Appl. No.: 10/821,410
Amdt. Dated: 12/14/2005
Off. Act. Dated: 09/14/2005

Amendments to the Drawings:

FIG. 5

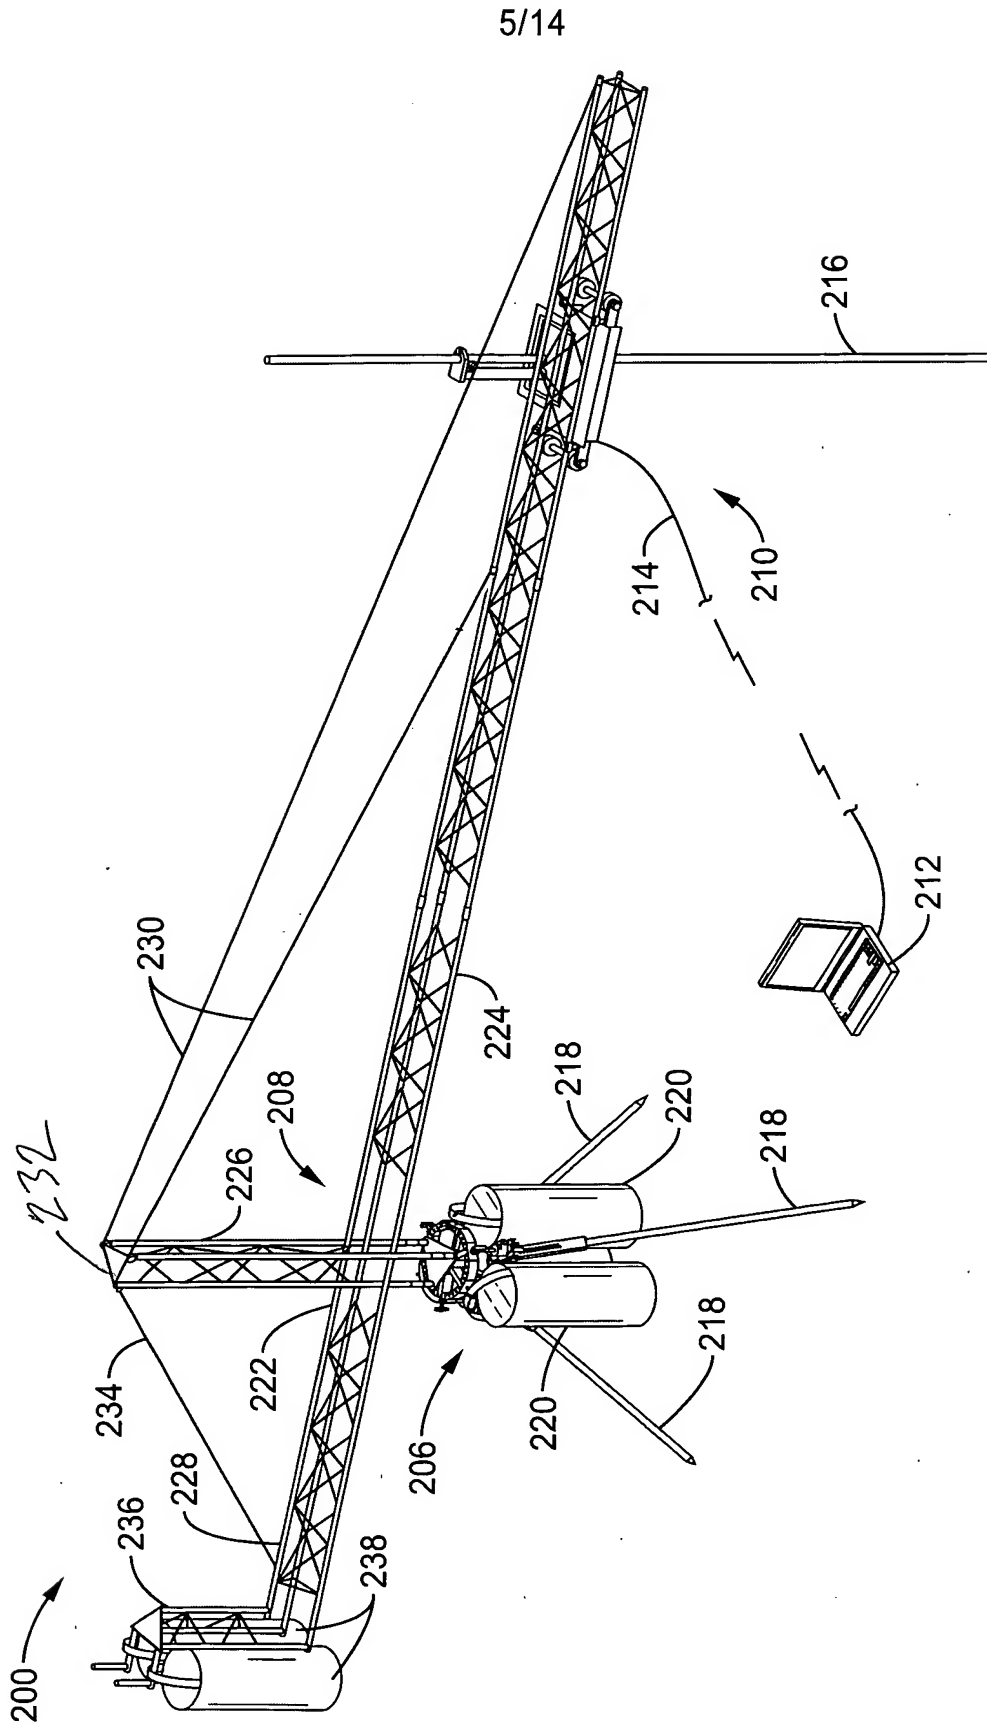
Sheet 5/14, which includes FIG. 5, replaces the original sheet including FIG. 5. In FIG. 5, element 232 was added for the mast top plate (see e.g., paragraph [0082] of the specification).

FIG. 12

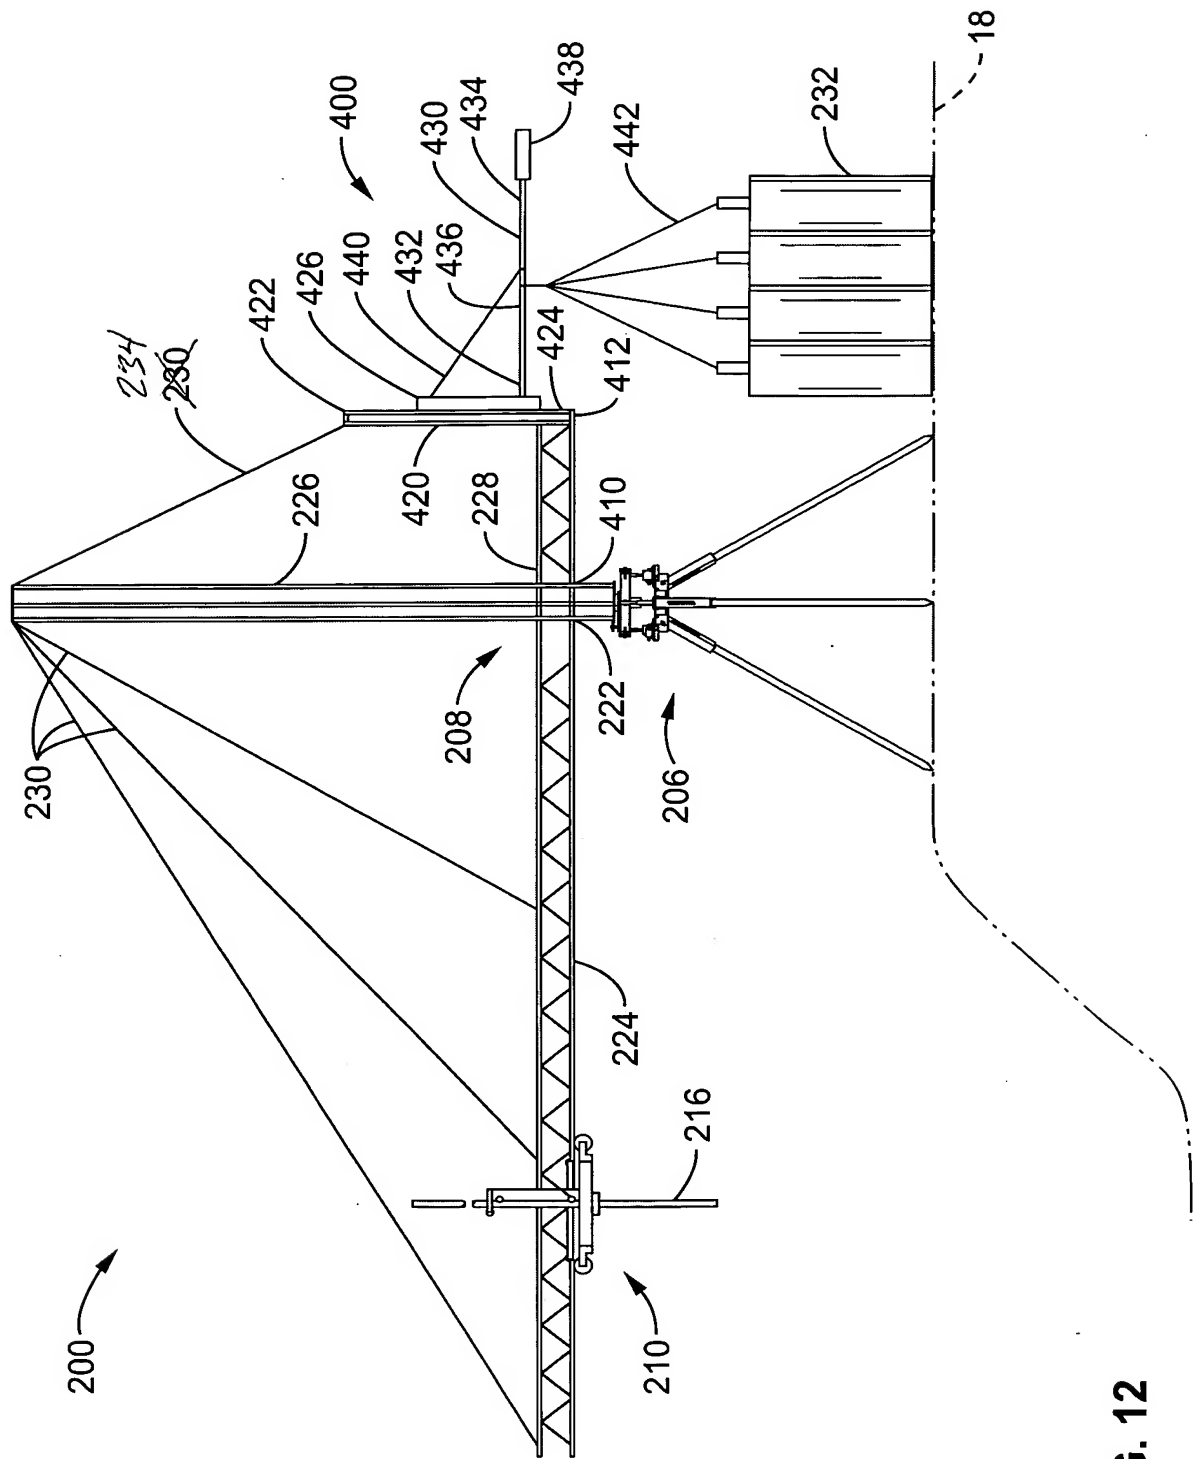
Sheet 12/14, which includes FIG. 12, replaces the original sheet including FIG. 12. In FIG. 12, the support wire leading to element 422 was corrected from 230 to 234 (see e.g., paragraph [0082] of the specification).
